Access Statement

Project: Mixed Use Retail and Residential Development

Address: 332-338 Sydney Road, Balgowlah NSW

Stage: Revised Development Application

Lower Basement - Access pathways from adaptable car spaces

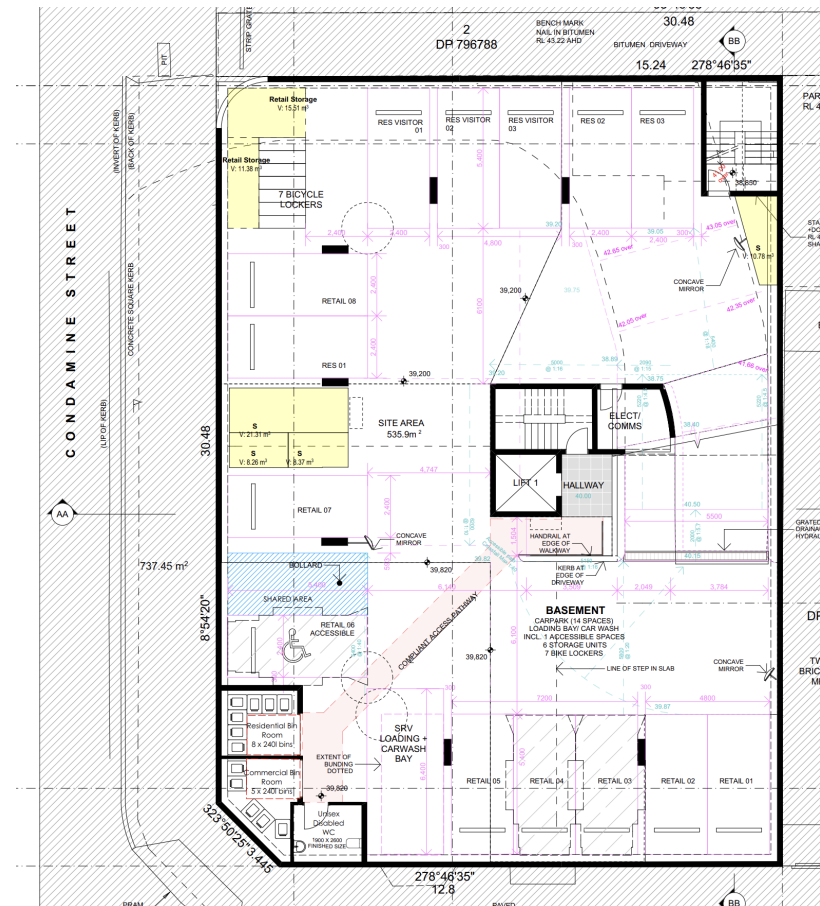
A revised access path is shown on the drawings, with the capacity to comply with AS1428.1 (2009) from the nominated three (3) adaptable unit parking spaces. An access pathway will be via the lift to the upper levels.

Basement - Access pathways from accessible car space and accessible toilet

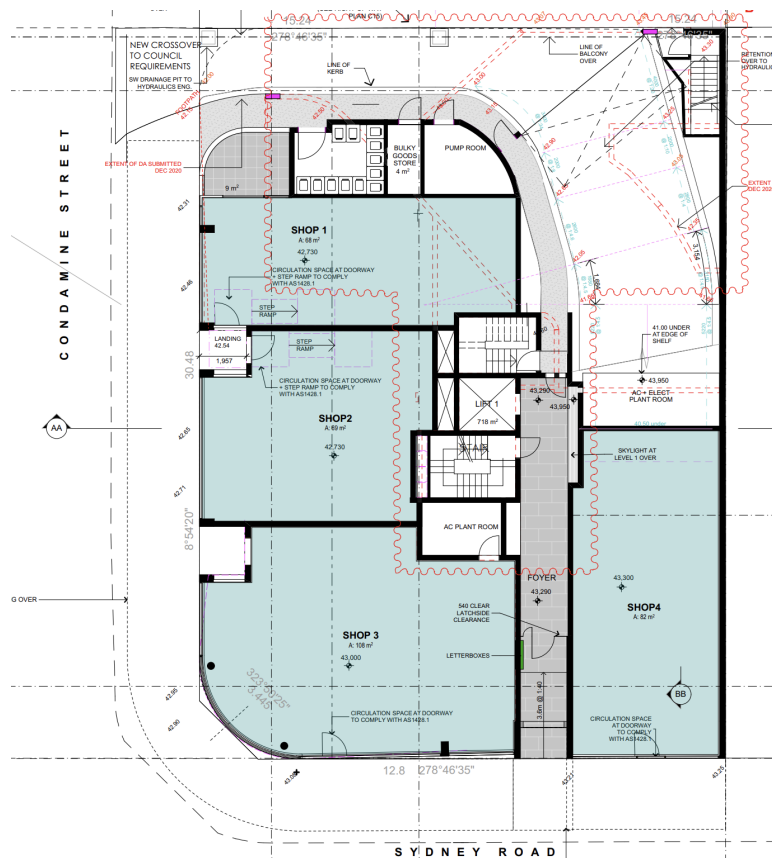
A revised access path is shown on the drawings from the proposed accessible toilet and retail accessible car space with the capacity to comply with AS1428.1 (2009). An access pathway will be via the lift to the upper levels.
